**TOWN OF DAVIDSON
DESIGN REVIEW BOARD
7:00PM Board Room in Town Hall a 216 S Main St, Davidson, NC**

Town of Davidson, NC
Design Review Board: Staff Analysis
July 17, 2019

Project: Wells Fargo ATM (Exxon Station Site)
Location: 601 Griffith Street (Parcel ID 00321403)
Applicant: Matthew Kiger, SVW Inc.
Designer: James M. Hammill, Prizm Architects
Planning Area: Special Use

Revised Wells Fargo ATM Renderings for Design Review Board (7/17/19)

Plans and Elevations

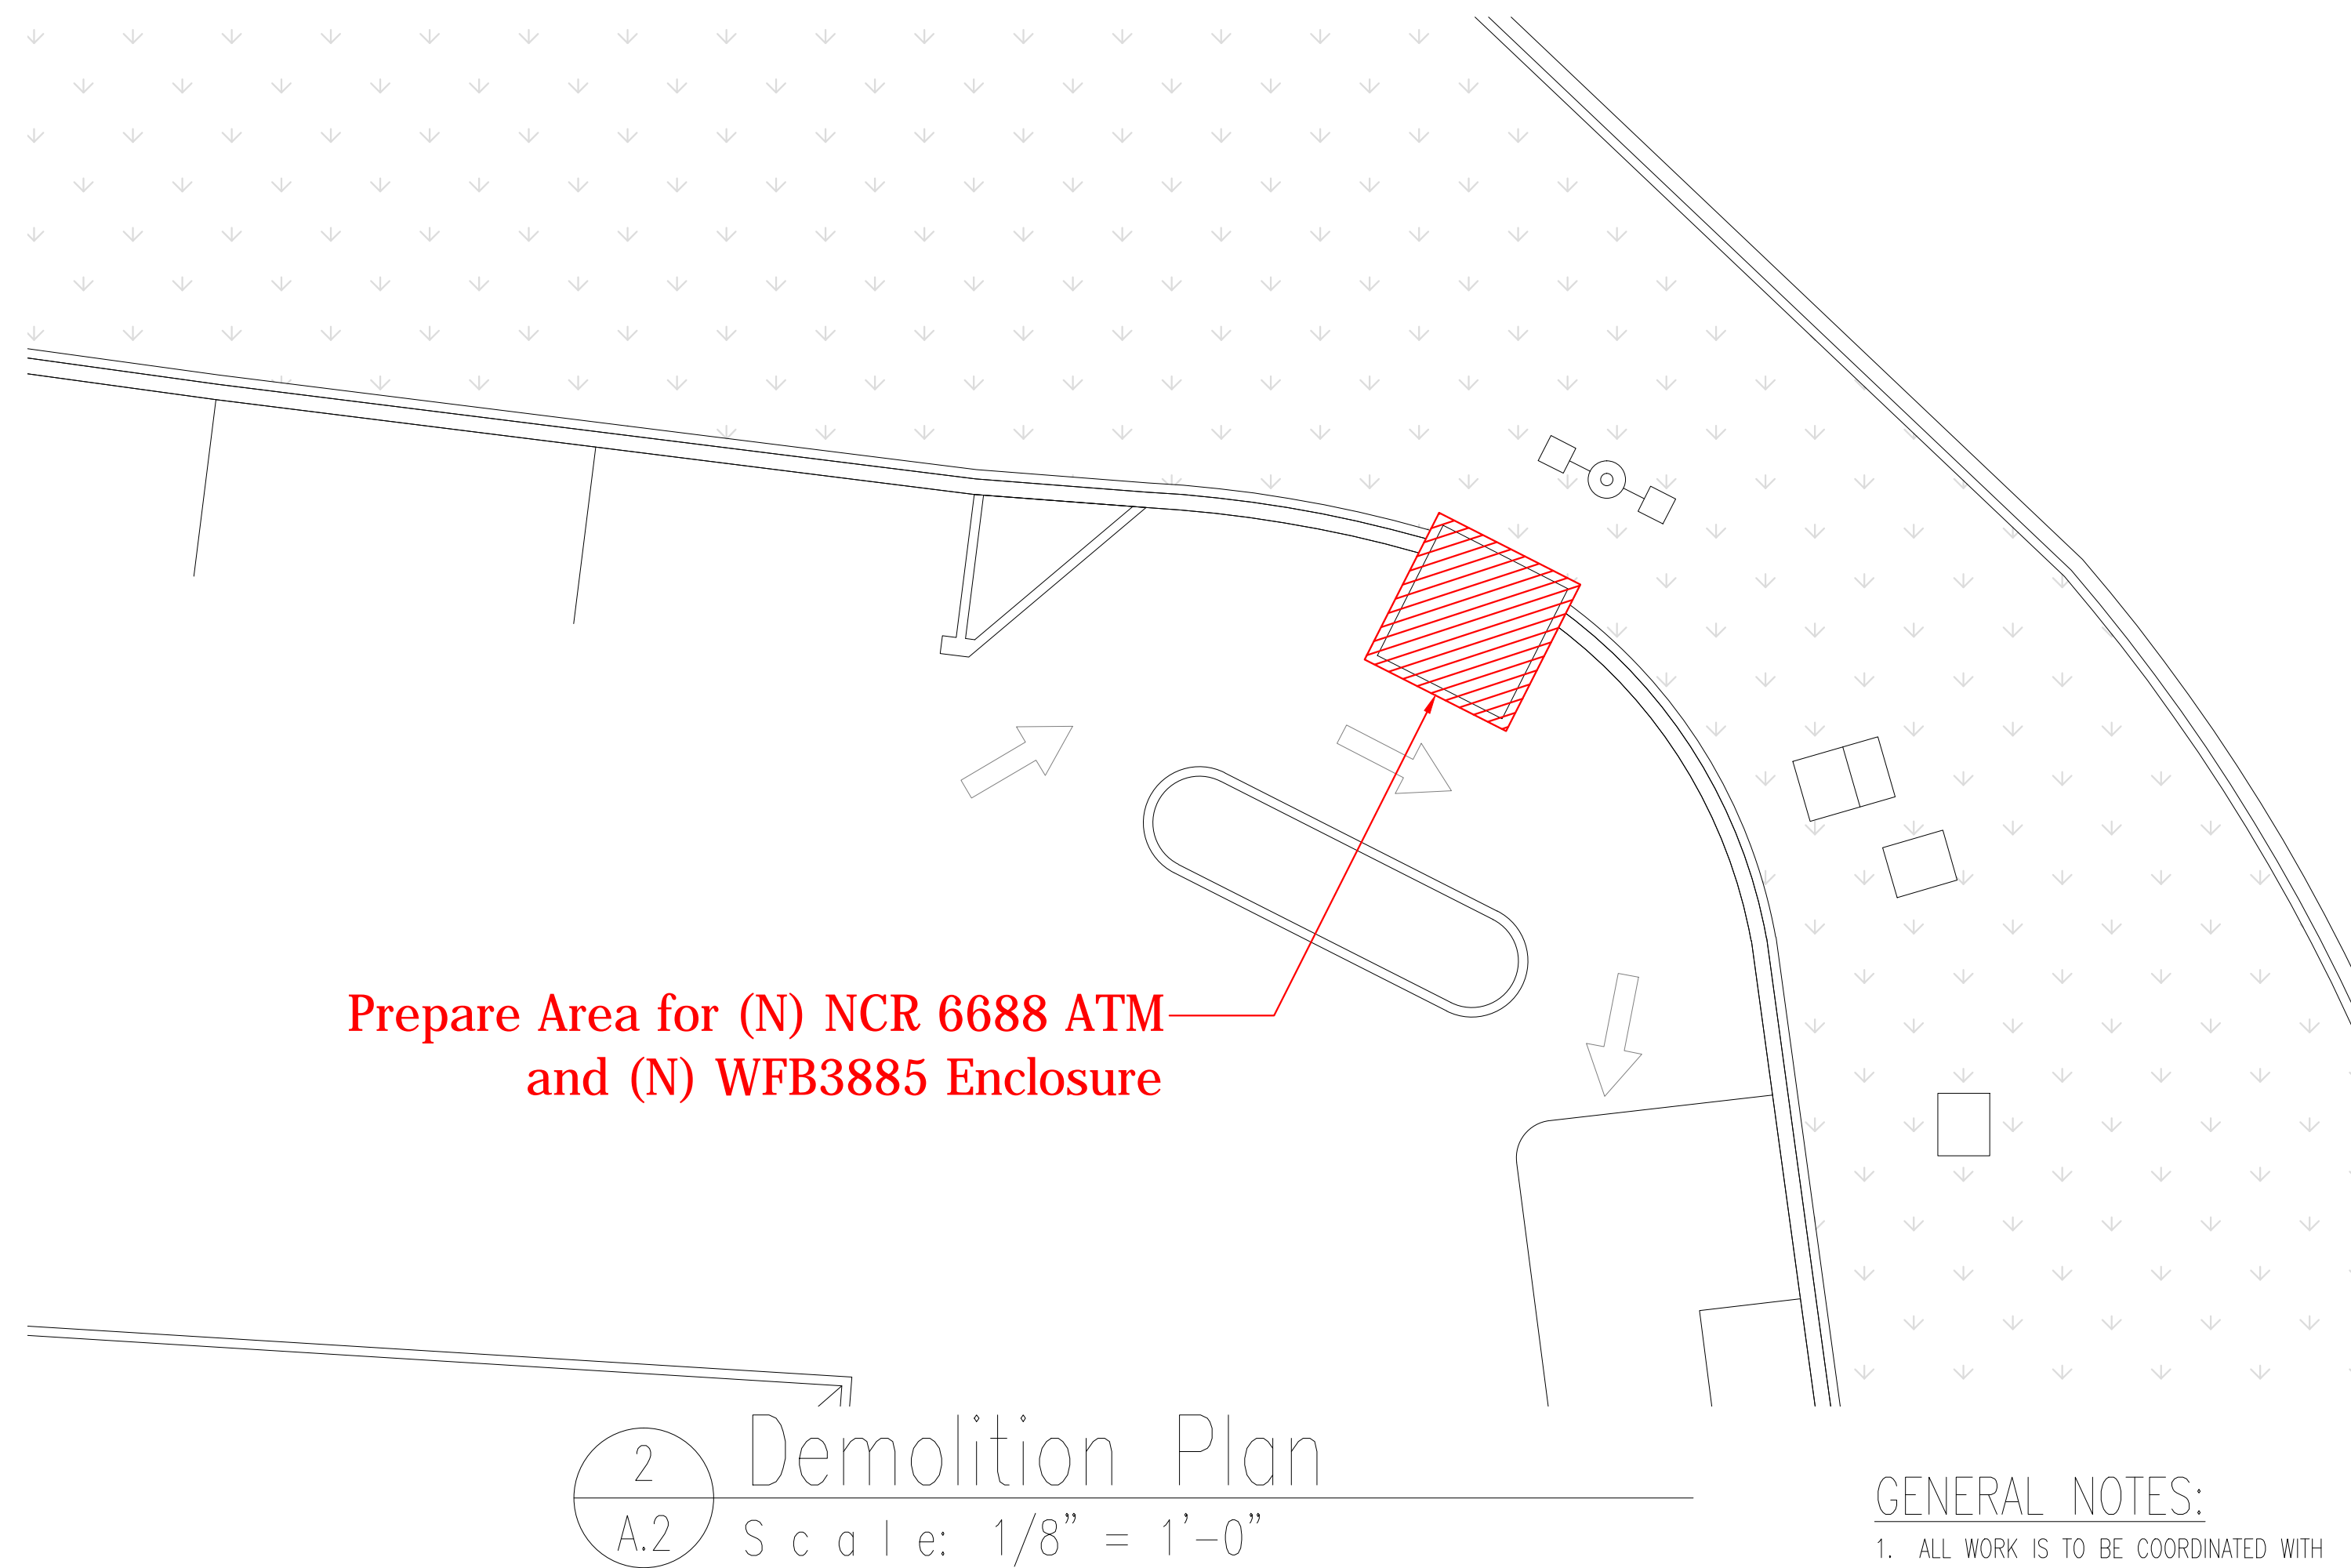
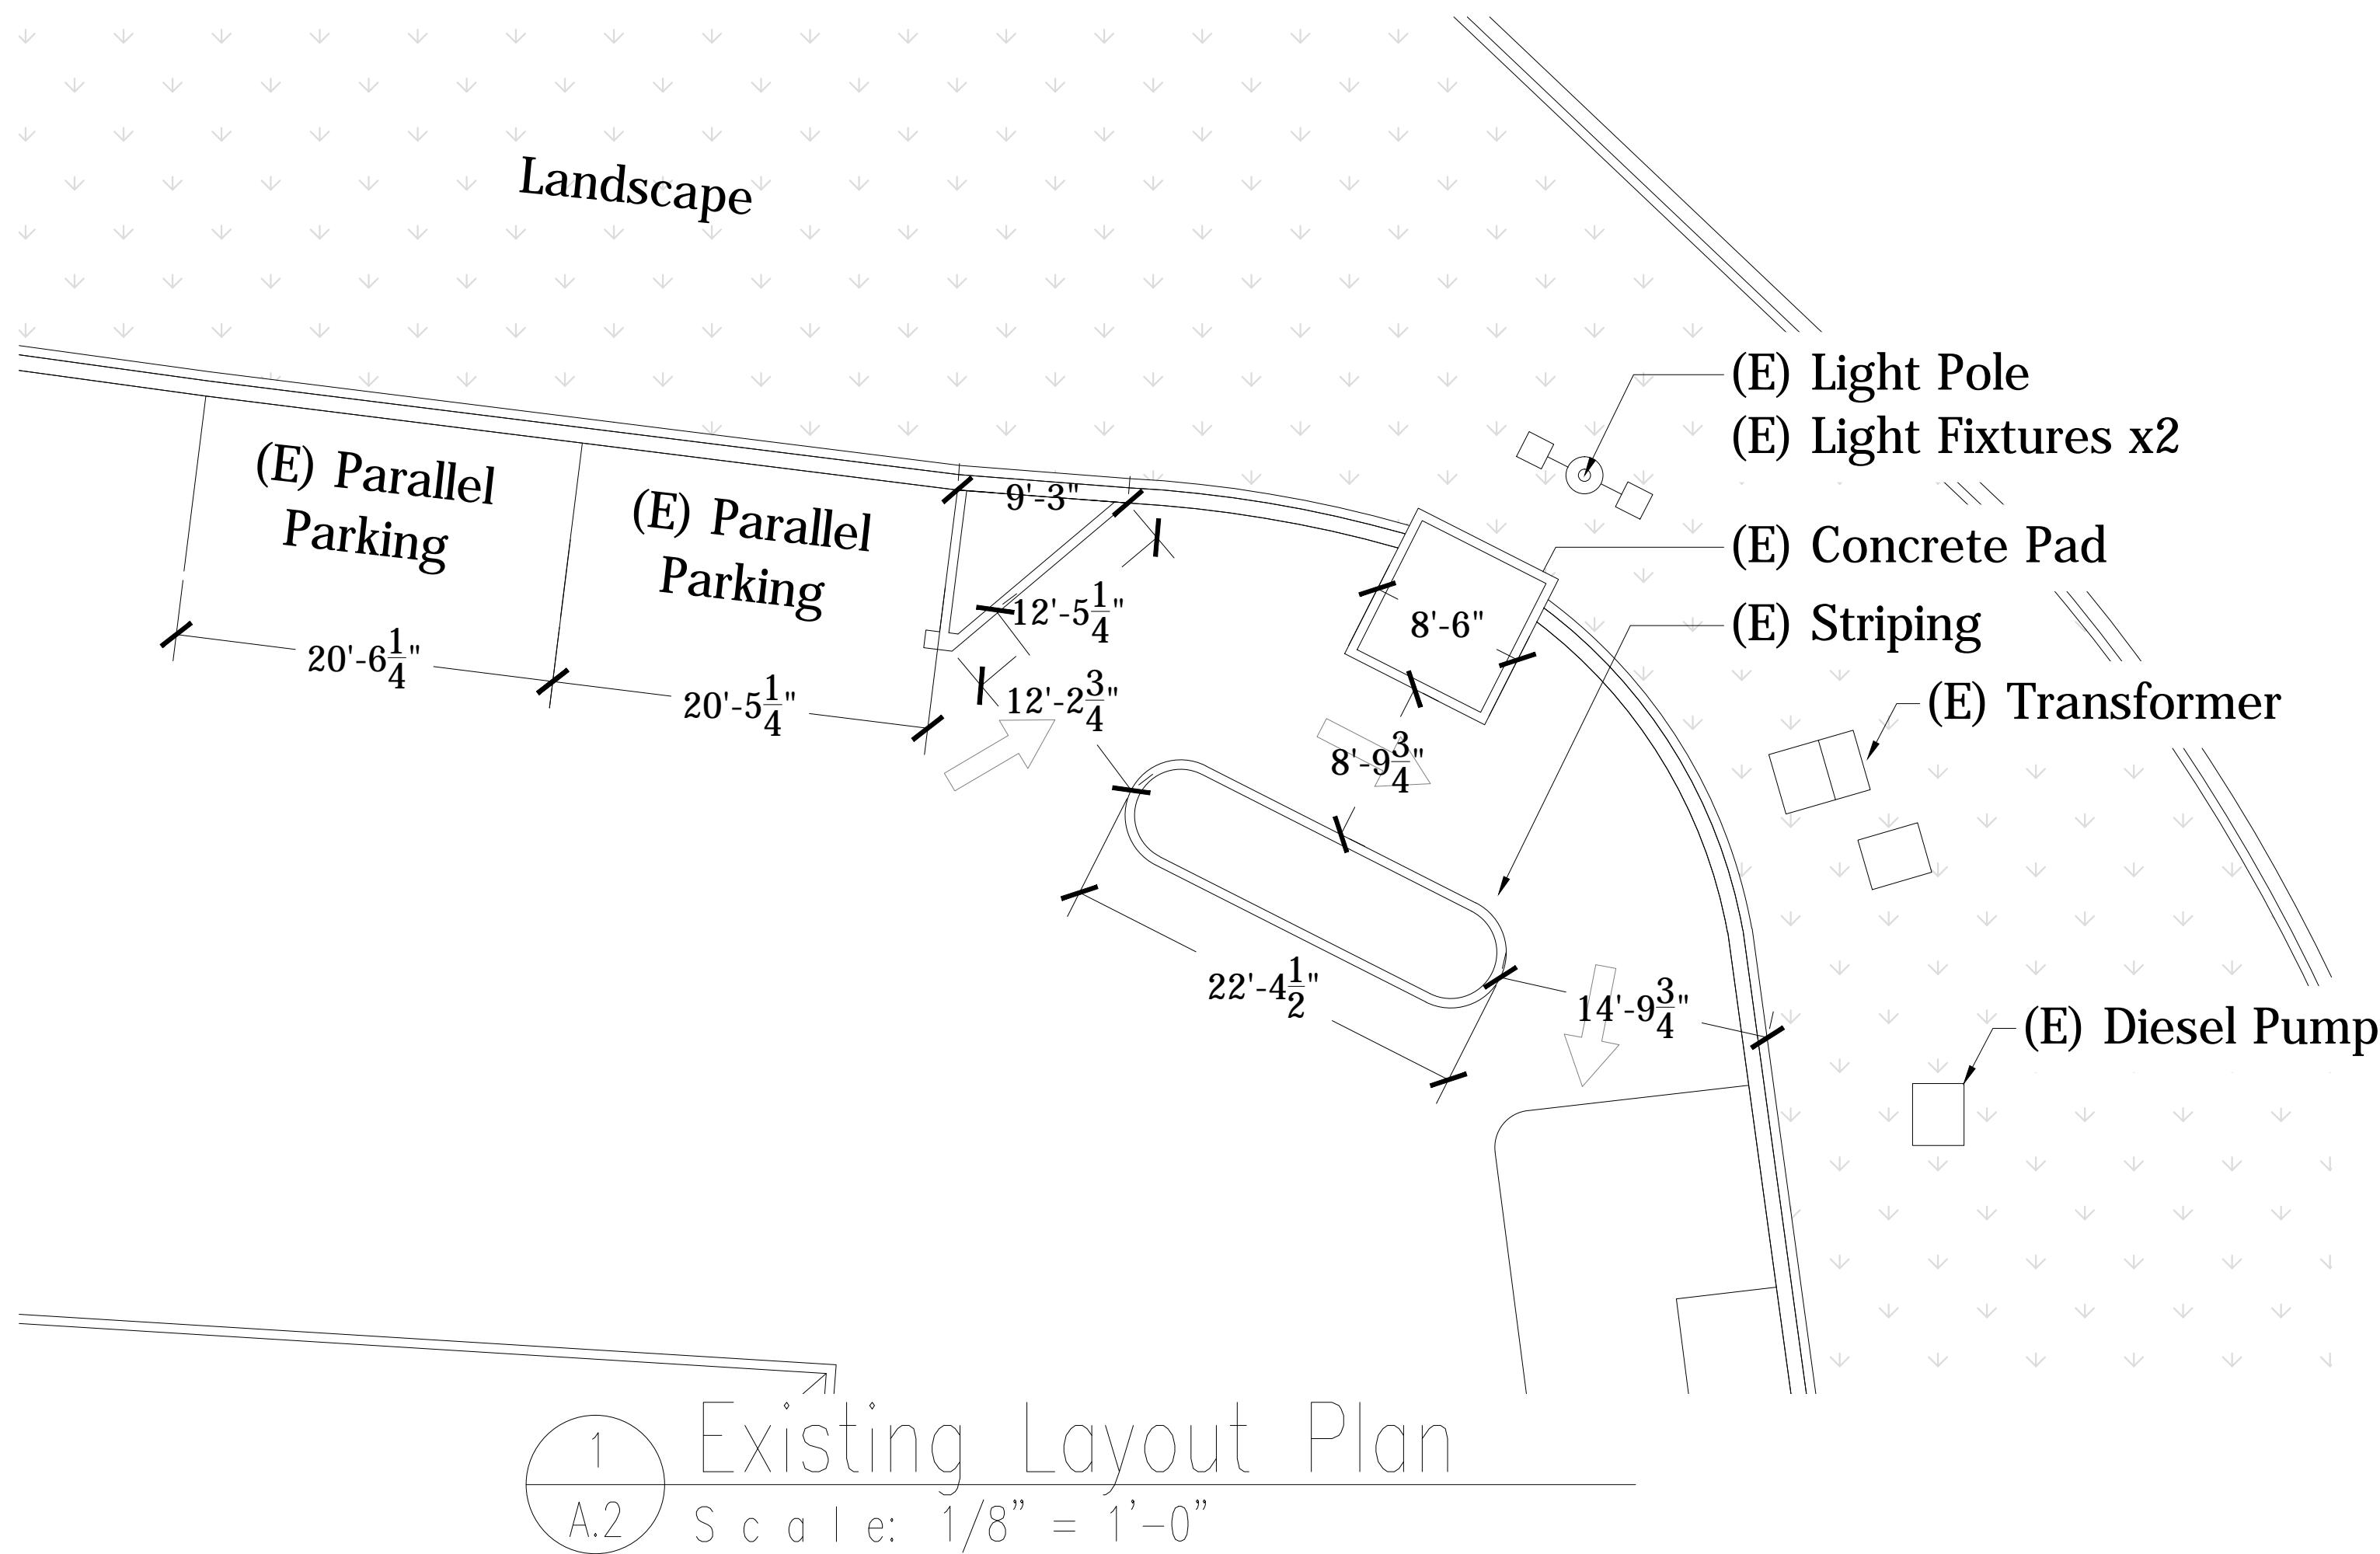
TG noted that materials must be complementary to the materials already being used in the neighborhood. The existing buildings adjacent to this site are primarily brick. Additionally, an electrical meter is shown on a pedestal facing the street in the plans submitted.

After further discussion, a motion (BS) was made to continue the project with the following requested changes: 1) the ATM enclosure shall be clad in brick to match adjacent buildings, 2) the electrical meter shall be reoriented so that it faces away from the side of the ATM structure and does not face the parking lot or the street, 3) the color of the light pole base and clearance bar shall be painted to match the meter pedestal (bronze), and 4) the signage on top of the ATM canopy shall not be internally illuminated. The motion was seconded (TG) and approved unanimously.

This case was continued at the June 19 DRB meeting with the following requested changes: 1) the ATM enclosure shall be clad in brick to match adjacent buildings, 2) the electrical meter shall be reoriented so that it faces away from the side of the ATM structure and does not face the parking lot or the street, 3) the color of the light pole base and clearance bar shall be painted to match the meter pedestal (bronze), and 4) the signage on top of the ATM canopy shall not be internally illuminated.

The location of the proposed ATM has not changed and will be located at the corner of the parking lot near the Griffith/Jetton St roundabout. The updated renderings of the proposed ATM show a change in exterior materials from metal/plexiglass to brick. The updated renderings also indicate that the electrical meter will no longer face the Griffith Street/Jetton Street roundabout. The applicant also indicated that the Wells Fargo signage on top of the ATM canopy can be installed without internal illumination.
